Subject: Description of Permissive Change

We, Miliwave Co., Ltd. hereby authorize Bay Area Compliance laboratory Corp. (Kunshan) to act as a laboratory for testing and test report generation for the following project(s):
FCC ID: 2AVCWMWC-708
Model Name: MWC-708
Original Grant Date: 2024/4/11

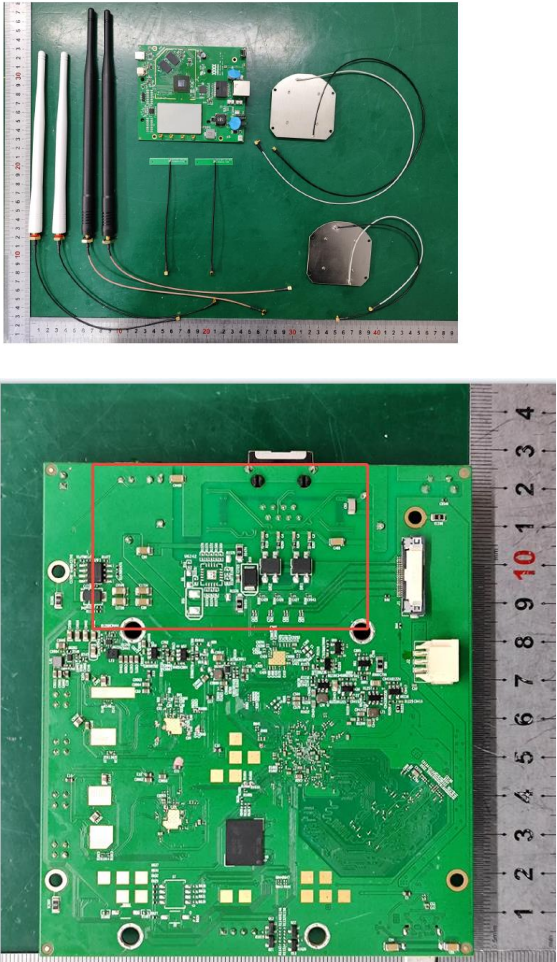
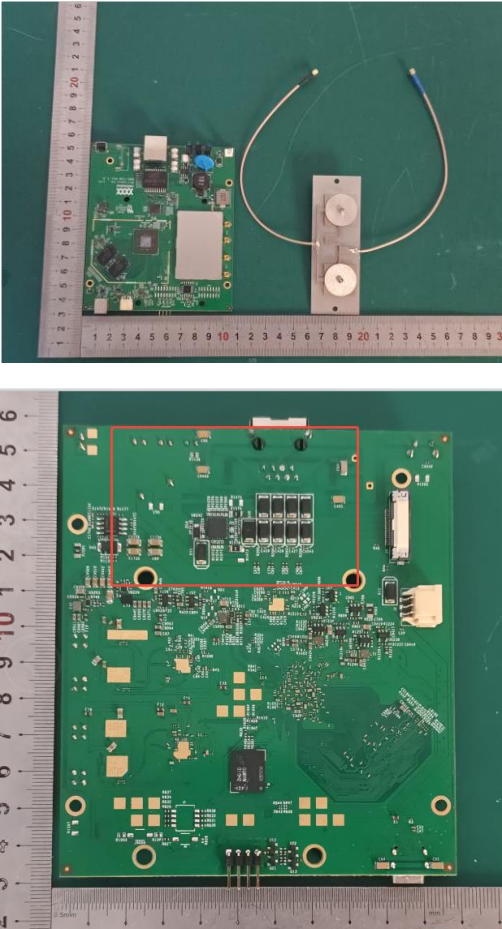
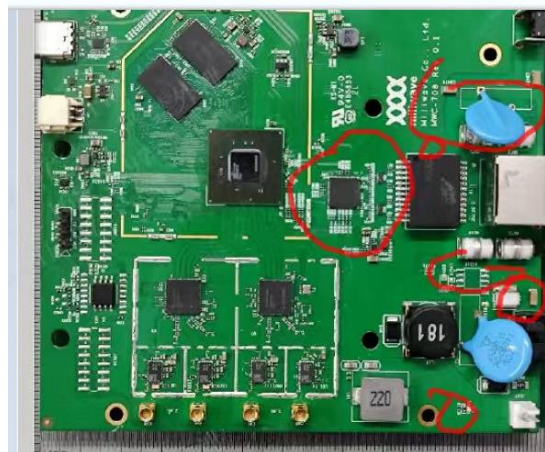
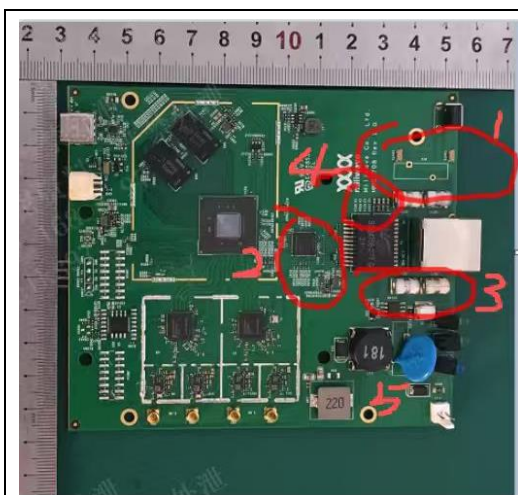
- 1) Add a 5G WIFI Antenna of model RN-117-01 5.8G
- 2) Remove one MOV
- 3) Add one MOSFET, remove a Capacitor and a LED
- 4) Put the capacitor on bottom side
- 5) Remove the led.
- 6) POE power supply circuit optimization
